ENTERED	1	DATE	2	DATE	3	DATE
						TLK				
DATE RECEIVED	FACILITY NAME	COUNTY No.	PROGRAM AREA CODE	FACILITY TYPE CODE	SUBJECT AREA CODE					
8-7-86	Ames, Iowa	85	CP	C05	Sludge Lagoon - Aeration 320					
RULE REFERENCE	DESIGN STANDARD REFERENCE		DECISION		APPEAL ACTION					
9 900-64.2(9)a	10 17.3.5.3		11 Approved 3-9-87		12					
ENGINEER			VARIANCE Rule							
13 Harris Seidel, Ames			14 900-64.2(9)c

15. DESCRIPTION OF VARIANCE REQUESTED: _____

The City of Ames is requesting that the mixing and aeration requirements stipulated in design standard IA 17.3.5.3 not be required for their digested sludge storage lagoon.

SUBJECT: Ames WPC Project No. C190736

Figure 8. Estimated Number of Days that Sludge Storage is Required Based Solely on Climatic Factors (Temperature, Precipitation, and Snowcover)

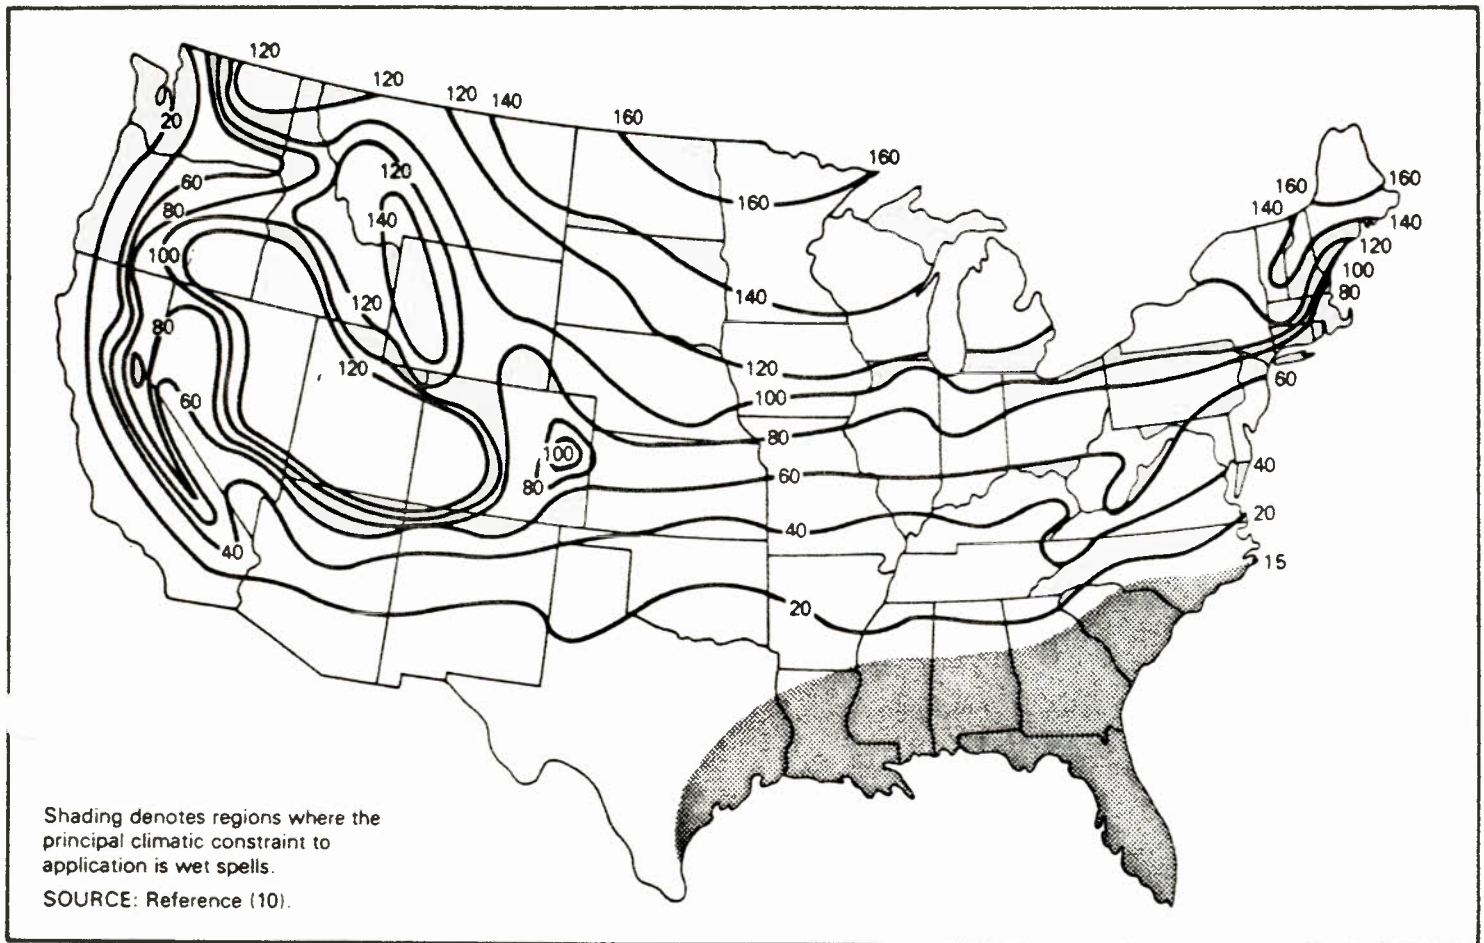
publication by EPA indicates that approximately 120 days would be appropriate for central Iowa (See attachment, Environmental regulations and technology page 12).

In conjunction with their secondary digester and sludge storage lagoon Ames should have approximately 120 days of storage based on design assumptions. Approximately 180 days of storage will be available at initial loadings.
